## 製品標示及標籤內容之變更通知

## PS6R 型 電源供應器

茲因 PS6R 型電源供應器取得 ANSI 標準的認證，因此製品的標示內容及標籤內容也隨之變更，特此通知。

- PS6R 型電源供應器的標示 (例:PS6R-F24)  
製品 TOP 面標示

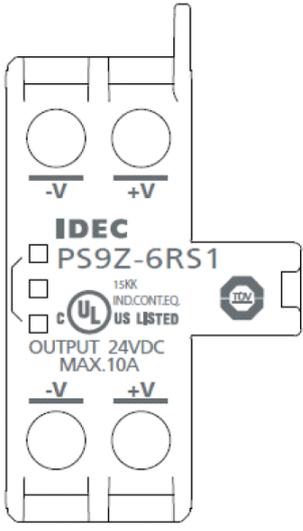
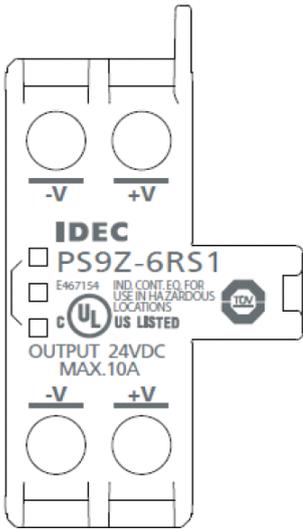
變更全機種 UL 標準的標示內容。另外，關於電源供應器 3 機種，除了變更製品標籤的記載內容之外，還追加法文標示。
